**SB-10029104-4598**SI B13 04 09  
Fuel SystemsMay 2013  
Technical Service

This Service Information bulletin supersedes SI B13 04 09 **dated March 2013.**

**SUBJECT****N54 Engine: Diagnosis of Cold Start Rough Running with Misfire Faults****MODEL**

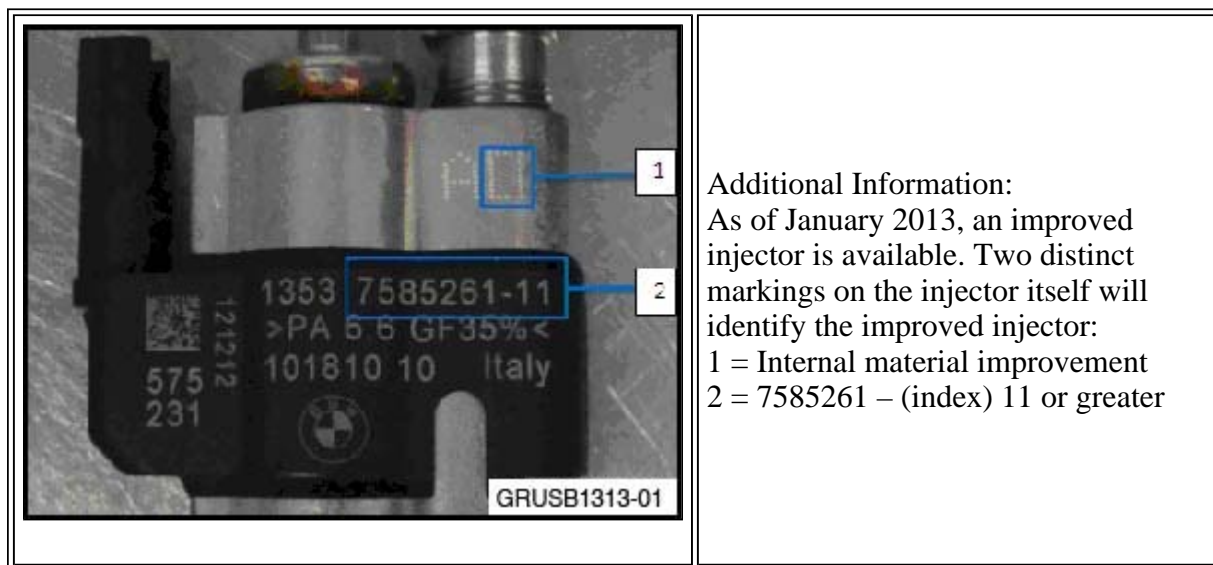
In the case of reproducible “cold start” rough engine running with corresponding misfire faults, replace all three high-pressure injectors on the bank that is faulted (1-3 or 4-6) using improved P/N 13 53 8 616 079 with index 11 or higher.

For example, if the engine has a misfire on cylinder 1, replace injectors for cylinders 1-3 if those **injectors are not already index 11 or higher**.

If the **injectors** on that bank are **already index 11 or higher**, only replace the injector on the faulty cylinder.

See the photo below to properly identify the index number.

**IMPORTANT: Injectors with index 11 and higher have a different calibration and construction than injectors with index 10 and lower.**

**Due to this difference, the injectors with index 11 and higher and injectors with index 10 and lower cannot be mixed on the same engine bank (i.e., cylinders 1-3 or 4-6).**

Use **P/N 13 53 8 616 079** when replacing the injector(s).
